DESCRIPTION Ltr notarized 3-22-77 request for changes
to info submitted in accordance with Sect. V.B.
of App I to 10CFR Part 50 on June 3, 1976 & trans
the following: 1PENCLOSURE Amdt to 6-3-76 submittal which
consists of Figure 3-1 & 3-2 entitled
Gaseous Waste Schematic-Base Case....
(2P)

PLANT NAME: Duane Arnold Plant

March 22, 1977
IE-77-601

Figure 3-1

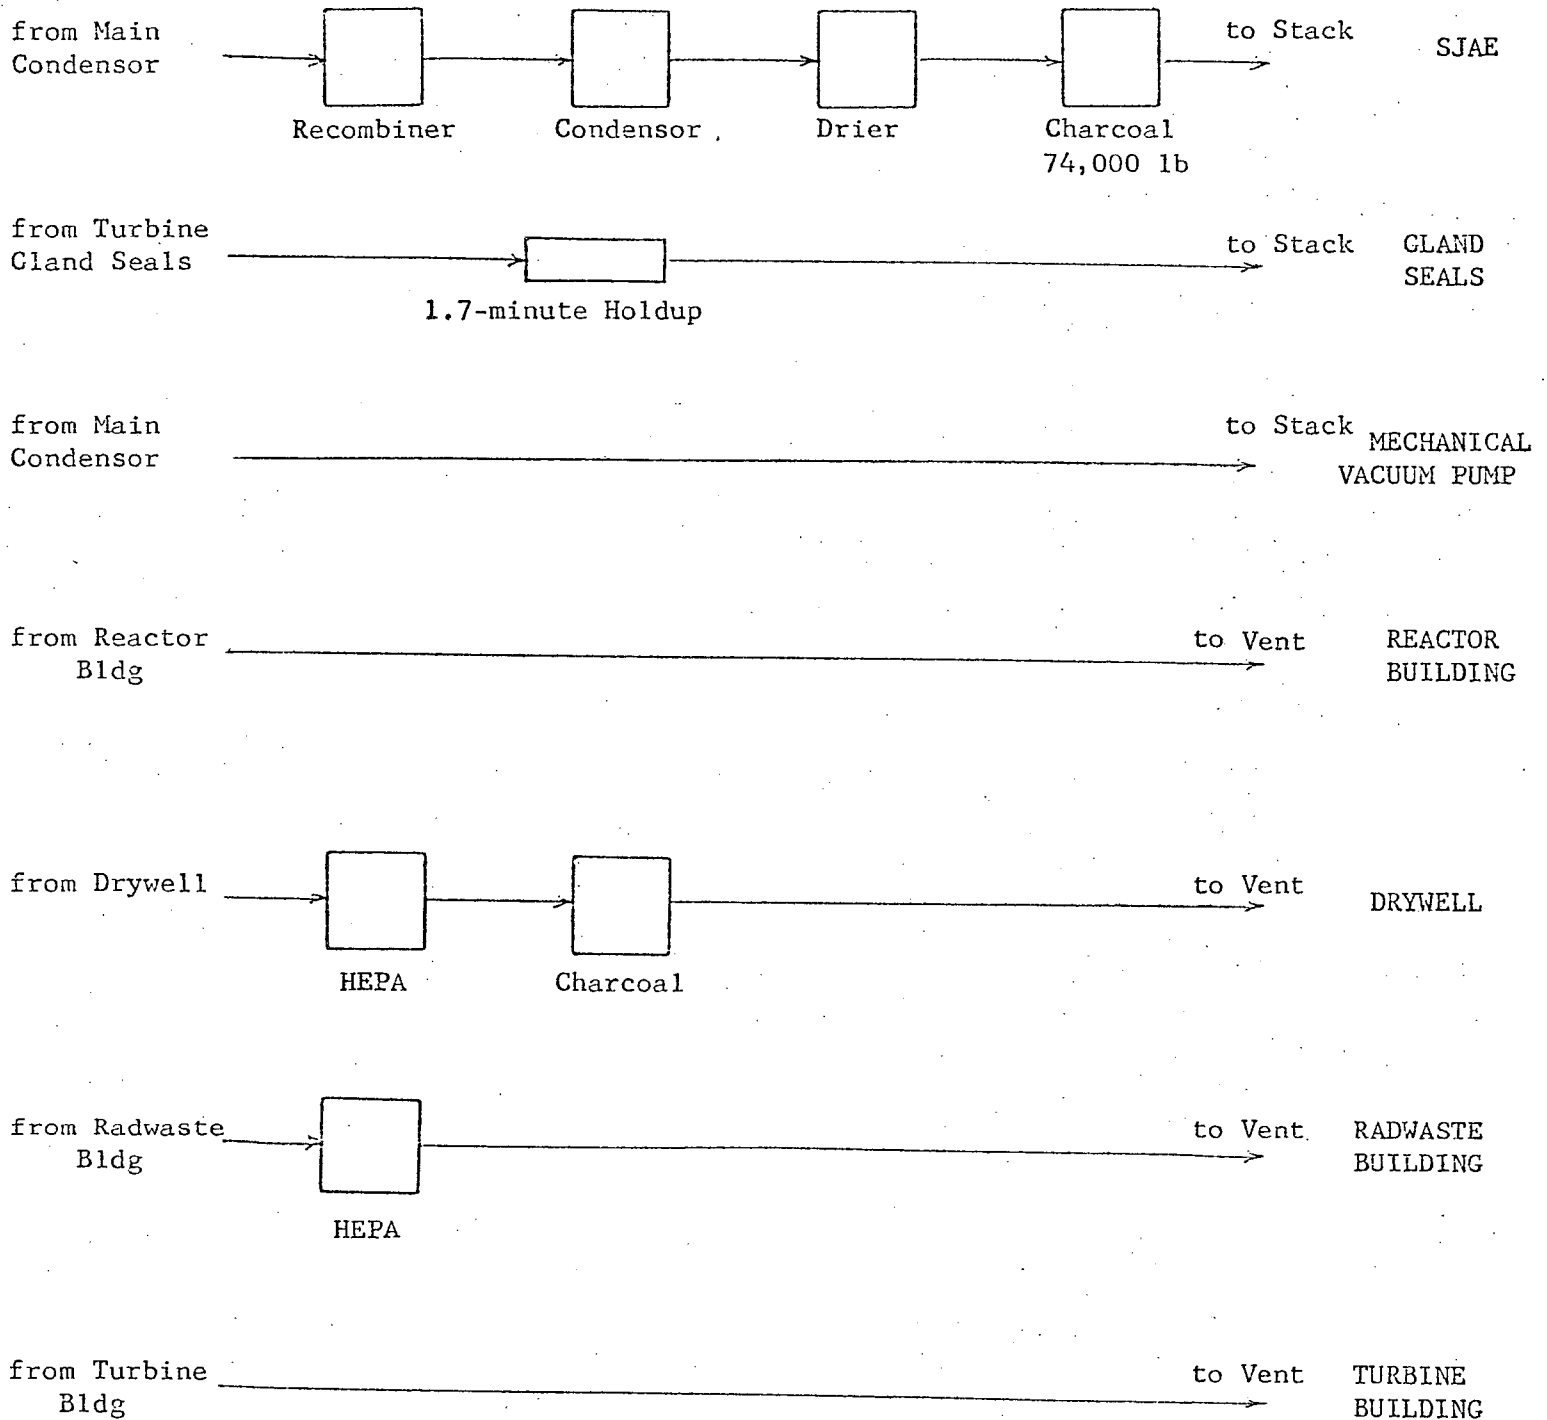
On June 3, 1976 we transmitted information as required by Section V.B of Appendix I to 10CFR Part 50. On August 30, 1976 we amended that information. We hereby further amend that information with the enclosed page changes.

The enclosed corrects inconsistencies in the information provided and does not change the conclusions stated in our June 3, 1976 submittal.
